## City of Ketchum

### **Recommendation to Hold a Public Hearing and Approve the Buck Subdivision Lot Line Shift Final Plat & Findings of Fact, Conclusions of Law, and Decision**

IN RE: )  
 )  
Buck Subdivision Lot Line Shift ) KETCHUM CITY COUNCIL  
Lot Line Shift ) FINDINGS OF FACT, CONCLUSIONS OF LAW, AND  
Date: November 1, 2021 ) DECISION  
 )  
File Number: P21-065 )

Lots 1A & 2A, Buck Subdivision Plat

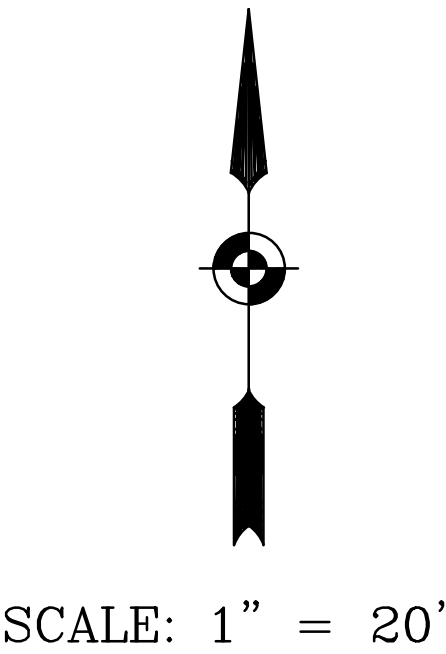
area of each lot, boundaries of floodplain and floodway and avalanche district, all with bearings, accurate dimensions in feet and decimals, in degrees and minutes and radii, arcs, central angles, tangents and chord lengths of all curves to the above accuracy.
			<b>Council Findings</b>	<i>The plat indicates Warm Springs Road and W Canyon Run Boulevard as well as the utility and snow storage easements.</i>  <i>As conditioned, this standard shall be met. The final plat mylar shall show tract boundary lines, property lines, lot lines, street right of way lines and centerlines, other rights of way and easement lines, building envelopes as required on the preliminary plat, lot area of each lot, boundaries of floodplain and floodway and avalanche district, all with bearings, accurate dimensions in feet and decimals, in degrees and minutes and radii, arcs, central angles, tangents and chord lengths of all curves to the above accuracy.</i>

<input checked="" type="checkbox"/>	<input type="checkbox"/>	<input type="checkbox"/>	<b>16.04.030.K.4</b>	<b>Names and locations of all adjoining subdivisions.</b>
			<b>Council Findings</b>	<i>The plat indicates the adjacent Sun Valley Subdivision to the north. As this standard shall be met, the final plat mylar shall show the names and locations of all adjoining subdivision.</i>
<input checked="" type="checkbox"/>	<input type="checkbox"/>	<input type="checkbox"/>	<b>16.04.030.K.5</b>	<b>Name and right of way width of each street and other public rights of way.</b>
			<b>Council Findings</b>	<i>This standard has been met. The plat indicates the Warm Springs Road and W Canyon Run Boulevard public rights-of-way.</i>
<input checked="" type="checkbox"/>	<input type="checkbox"/>	<input type="checkbox"/>	<b>16.04.030.K.6</b>	<b>Location, dimension and purpose of all easements, public or private.</b>

<b>Council Findings</b>	<i>This standard has been met. The plat indicates the utility and snow storage easements.</i>
<input checked="" type="checkbox"/>	<input type="checkbox"/>	<input type="checkbox"/>	<b>16.04.030.K.7</b>	<b>The blocks numbered consecutively throughout each block.</b>
			<b>Council Findings</b>	<i>This standard has been met.</i>
<input type="checkbox"/>	<input type="checkbox"/>	<input checked="" type="checkbox"/>	<b>16.04.030.K.8</b>	<b>The outline of any property, other than a street, alley or easement, which is offered for dedication to public use, fully dimensioned by distances and bearings with the area marked "Dedicated to the City of Ketchum for Public Use", together with any other descriptive language with regard to the precise nature of the use of the land so dedicated.</b>
			<b>Council Findings</b>	<i>N/A as no dedications of this type have been proposed.</i>
<input checked="" type="checkbox"/>	<input type="checkbox"/>	<input type="checkbox"/>	<b>16.04.030.K.9</b>	<b>The title, which shall include the name of the subdivision, the name of the city, if appropriate, county and state, and the location and description of the subdivision referenced to section, township, range.</b>

<b>Council Findings</b>	As conditioned, this standard will be met prior to recordation of the Final Plat. The signature block page shall include a certificate of ownership and associated acknowledgement from all owners and holders of security interest with regard to the subject property, which shall be signed following Ketchum City Council review and approval of the application and prior to recordation of the Final Plat.
<input checked="" type="checkbox"/>	<input type="checkbox"/>	<input type="checkbox"/>	<b>16.04.030.K.16</b>	<b>Certification and signature of engineer (surveyor) verifying that the subdivision and design standards meet all city requirements.</b>
			<b>Council Findings</b>	As conditioned, this standard will be met prior to recordation of the Final Plat. The signature block page shall include the certification and signature of the surveyor verifying that the subdivision and design standards meet all City requirements.

1. The amended plat mylar shall meet all conditions specified in Table 1: Findings Regarding Contents of Final Plat and Subdivision Design & Development Requirements.

3. The recorded plat shall show a minimum of two Blaine County Survey Control Monuments with ties to the property and an inverse between the two monuments. The Survey Control Monuments shall be clearly identified on the face of the map.
